## Access Compliance Report Public Rights-of-Way (Curb Ramps)

Intersection ID: 29121 Main Street: APPLE\_GLEN\_LN Cross Street: HIGHLAND\_PARK\_DR Location: SW

ADA ID: C061822FDED3 Ramp Type: PerpDiag Initial Pass/Fail: Fail Overall Compliance: No Severity Score: 8.75

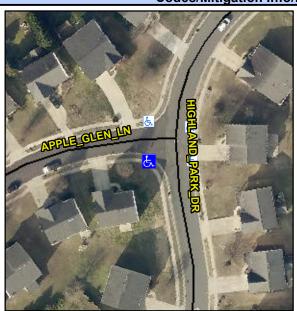
Not Found, R304.5.1

Compliance Description		Data	Compliance Description		Data
N/A	Ramp Length (in)	47.0	Yes	Ramp Slope (%)	7.6
No	Ramp Width (in)	47.0	Yes	Ramp XSlope (%)	0.1
N/A	Flare Type LT	N/A	N/A	Flare Type RT	N/A
N/A	Flare Slope LT (%)	N/A	N/A	Flare Slope RT (%)	N/A
N/A	Flare Traversable LT?	N/A	N/A	Flare Traversable RT?	N/A
N/A	Landing Length (in)	N/A	N/A	DWS Provided?	N/A
N/A	Landing Width (in)	N/A	N/A	DWS Contrast?	N/A
N/A	Landing Slope (%)	N/A	N/A	DWS Length (in)	N/A
N/A	Landing X Slope (%)	N/A	N/A	DWS Full Width?	N/A
N/A	Landing Curb? (Y/N)	N/A	N/A	DWS Offset (in)	N/A
N/A	Shared Landing?	N/A			
N/A	Gutter Ponding?	N/A	N/A	Gutter Slope (%)	N/A
N/A	Gutter Lip Ht (in)	N/A	N/A	Gutter X Slope (%)	N/A
N/A	Painted X Walk1?	No	N/A	Painted X Walk2?	No
	X Walk 1 Direction	To E		X Walk 2 Direction	To N
N/A	X Walk 1 Width (in)	N/A	N/A	X Walk 2 Width (in)	N/A
	X Walk 1 Slope (%)	0.1		X Walk 2 Slope (%)	2.1
	X Walk 1 X Slope (%)	2.9		X Walk 2 X Slope (%)	1.8

Remove & Replace Curb Ramp With
Two New Directional Ramps or
Equivalent.
